TRANS/WP.30/2002/22
23 August 2002

**CUSTOMS CONVENTION ON THE INTERNATIONAL TRANSPORT
OF GOODS UNDER COVER OF TIR CARNETS (TIR CONVENTION 1975)**

Amendment proposals for technical provisions of the Convention (TIR plate)

Note by the secretariat

The model of a TIR plate in conformity with Annex 5 is shown below.

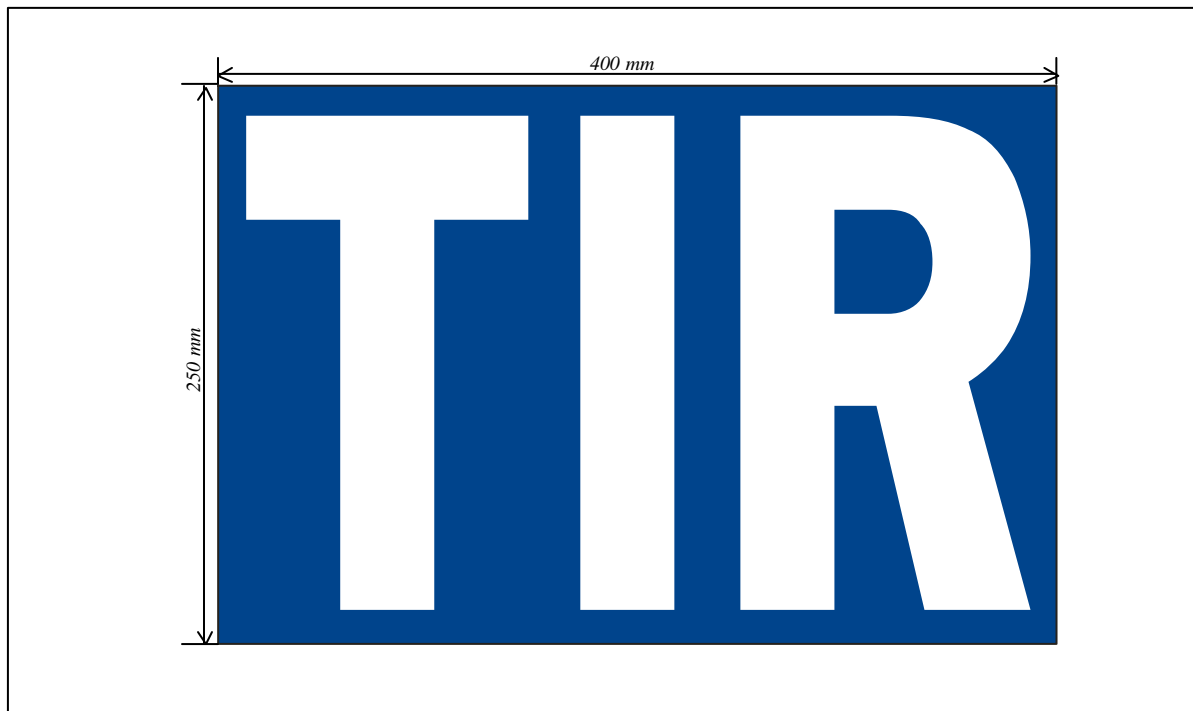
5. In order to give the TIR plate a uniform design, the secretariat proposes to replace the existing comment in Annex 5 by the following text:

White capital letters on blue ground (RAL 5017) [RAL 5005]

(Characters: 200 mm high; stroke width: at least 20 mm)
